Addendum No. 2

**For Project No. ENG2002905497
DEER CREEK MAINTENANCE BUILDING
DEER CREEK FISH & WILDLIFE AREA
Putnam County**

ISSUE DATE: June 28, 2023

Drawing Number:
G-1

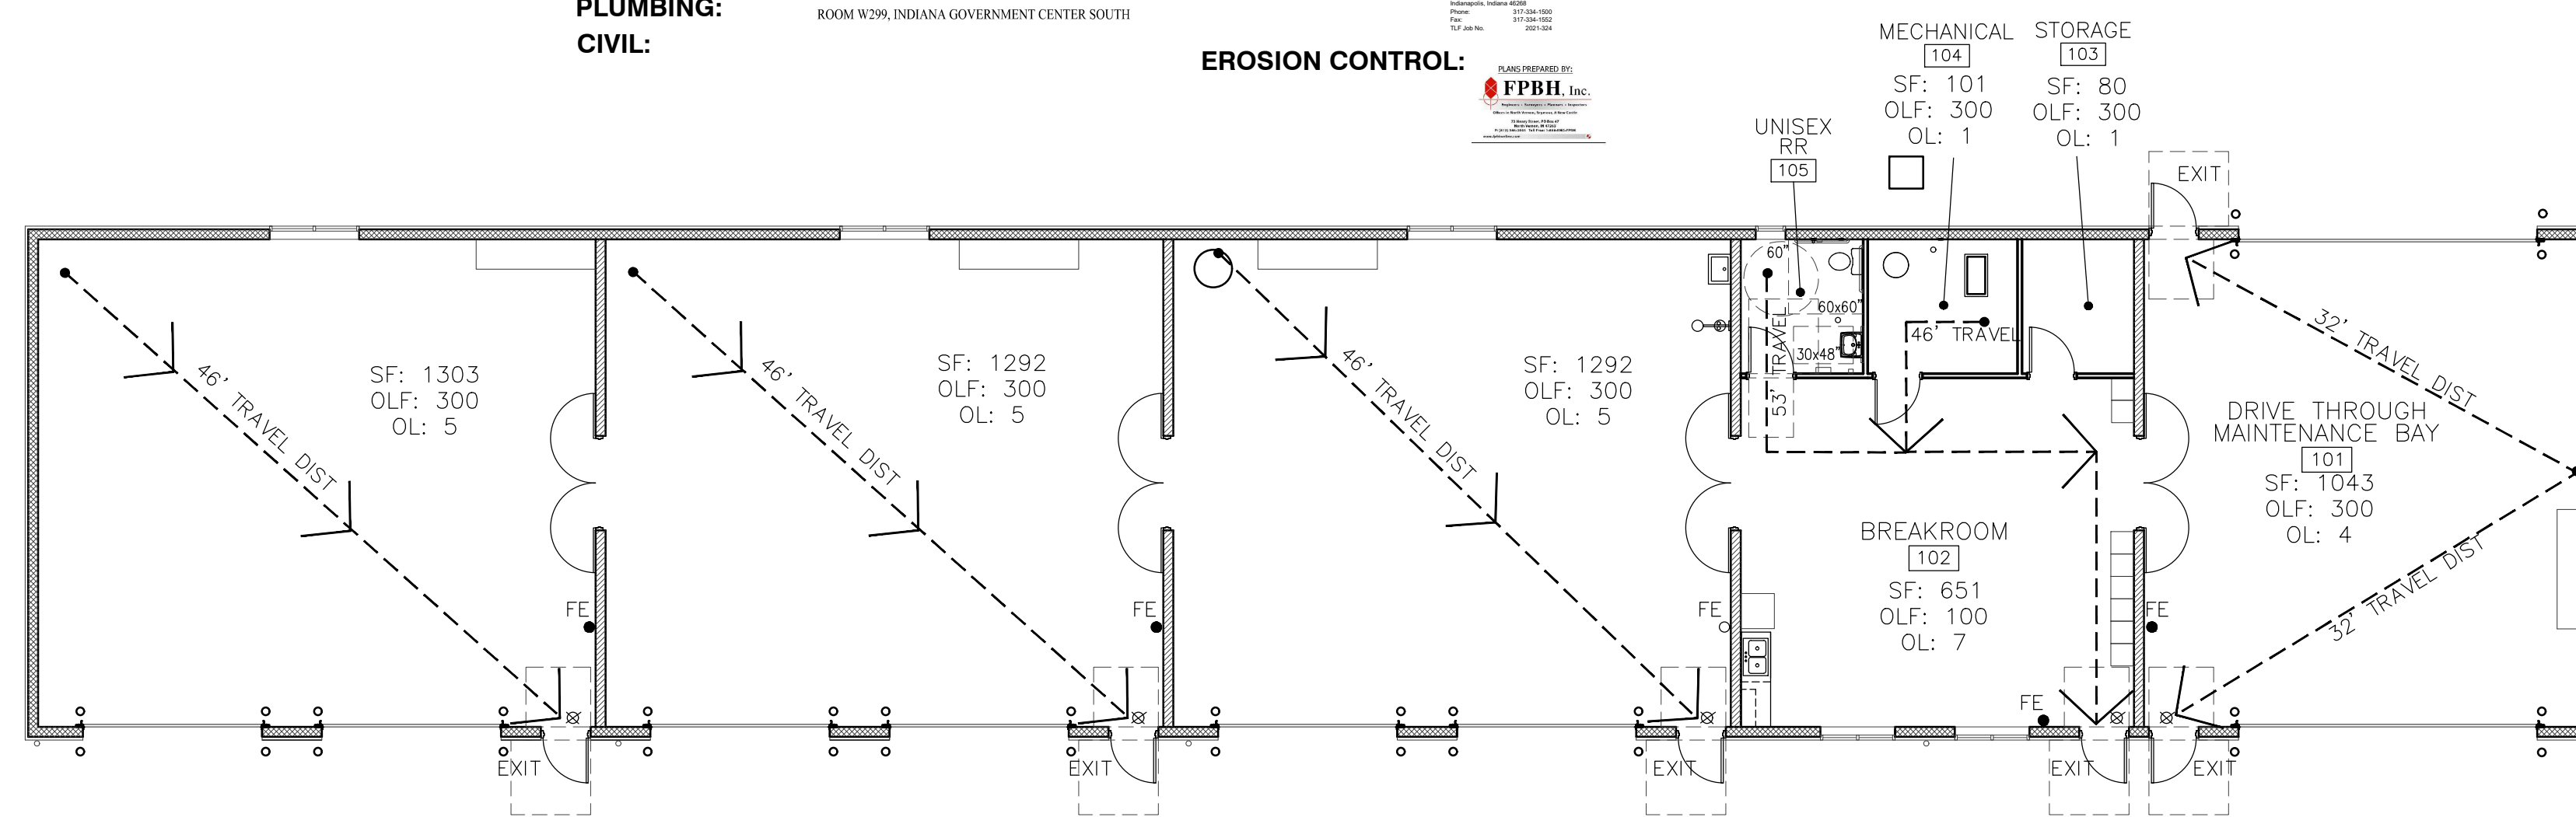
1. Sheet G-1:
Revised Building Address and County in the Project Information. Refer to attached plan.

Sheet: **C-1**
of

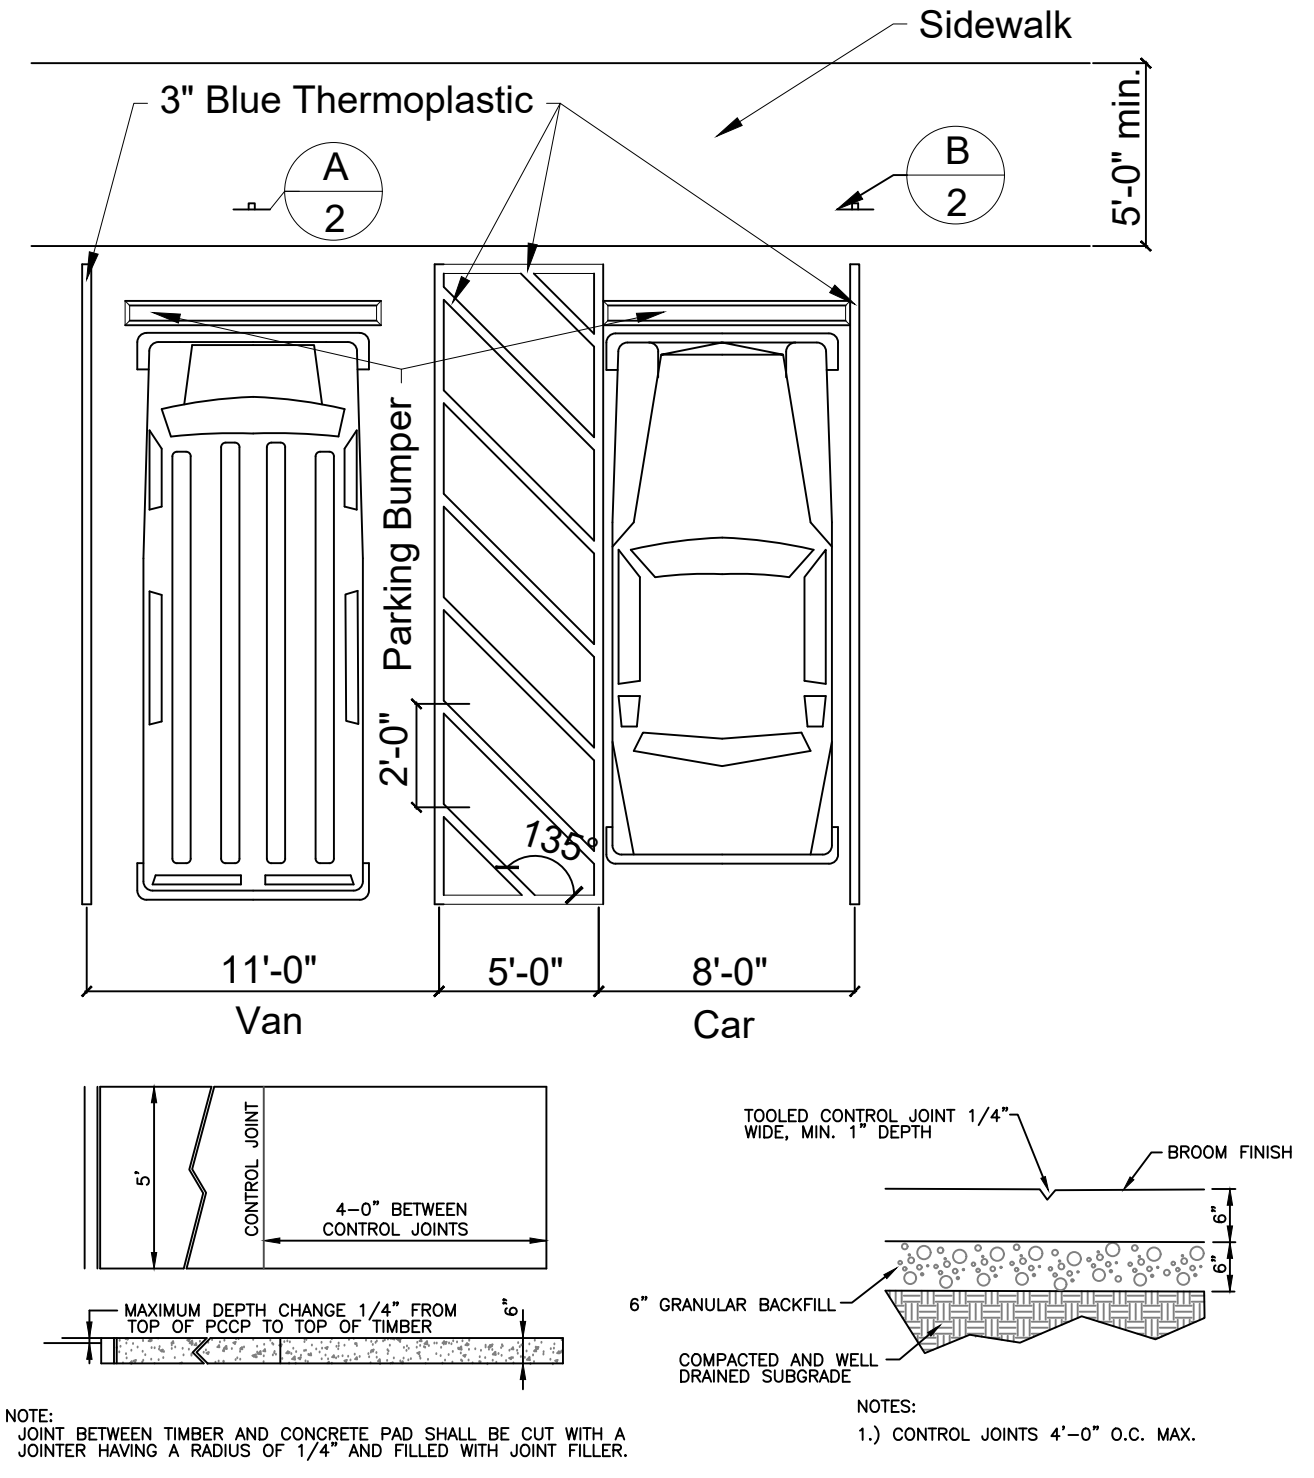
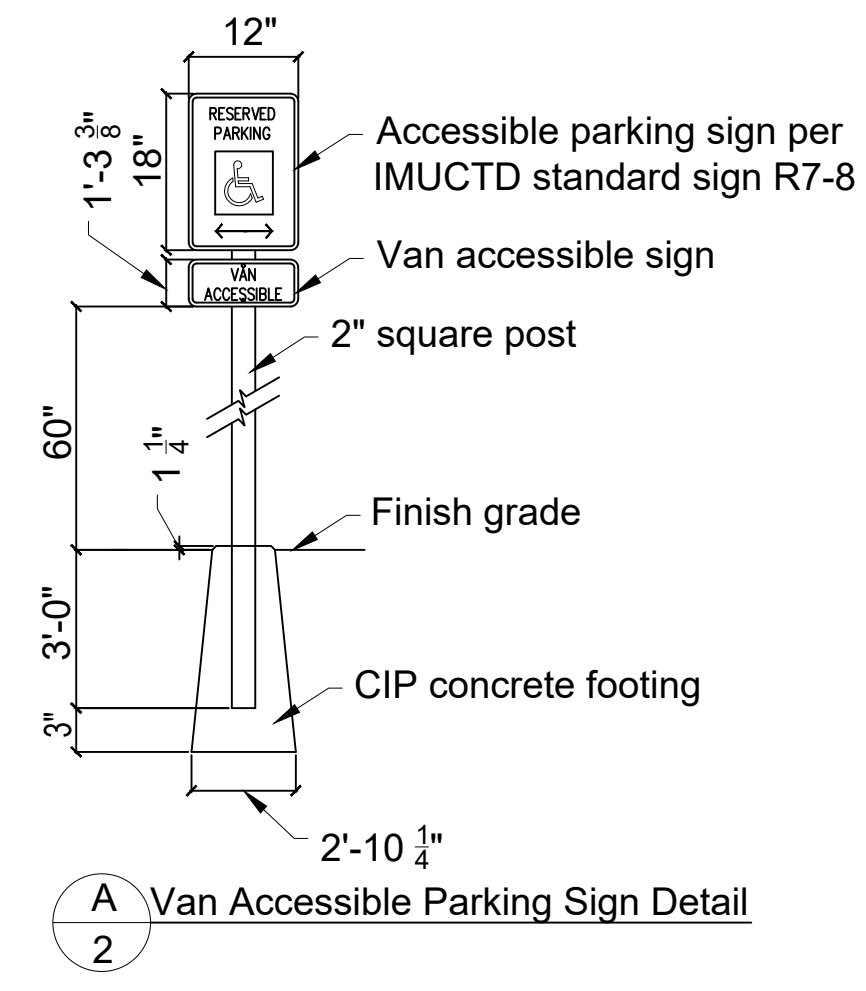
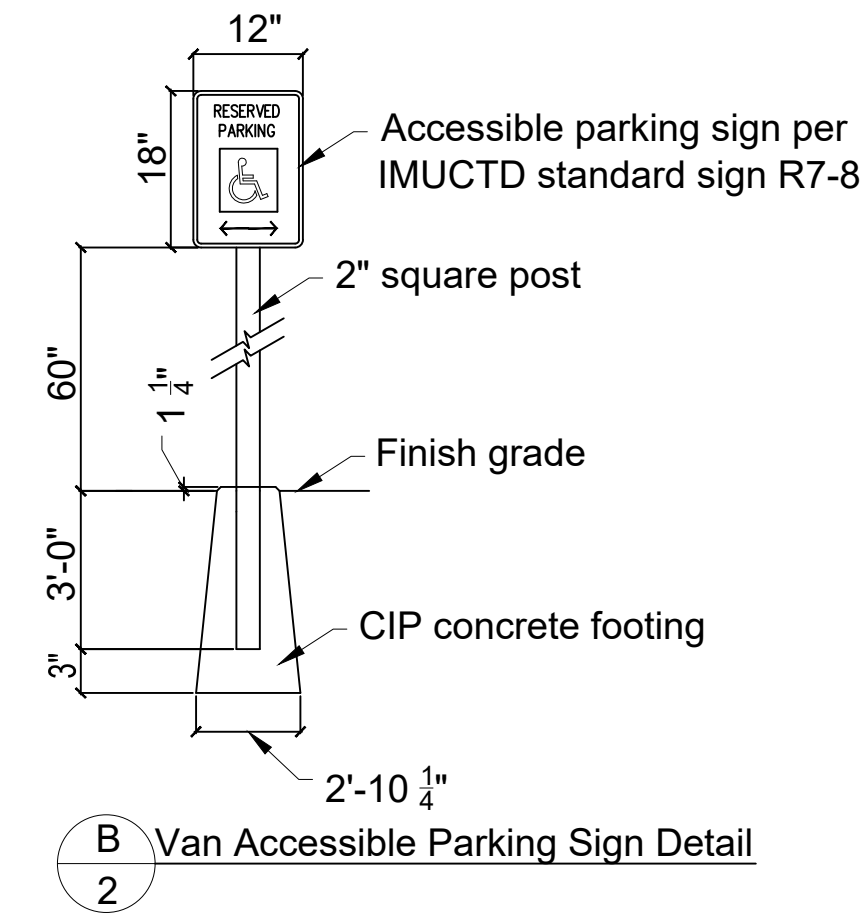
11. Q: Drawing C-1 shows two ADA parking spaces. Assuming these are concrete, there are no details on the structural or other drawings. Please provide details, including ADA details for ramps/slope.

- A: Sheet C-1 has been revised to include ADA parking details. Refer to attached drawings.
12. Clarification: Sheet D-1: Electric Control Panel. Conduit and wiring shall extend to new Maintenance Building. Land wiring at Panel A and provide 10 amp breaker.
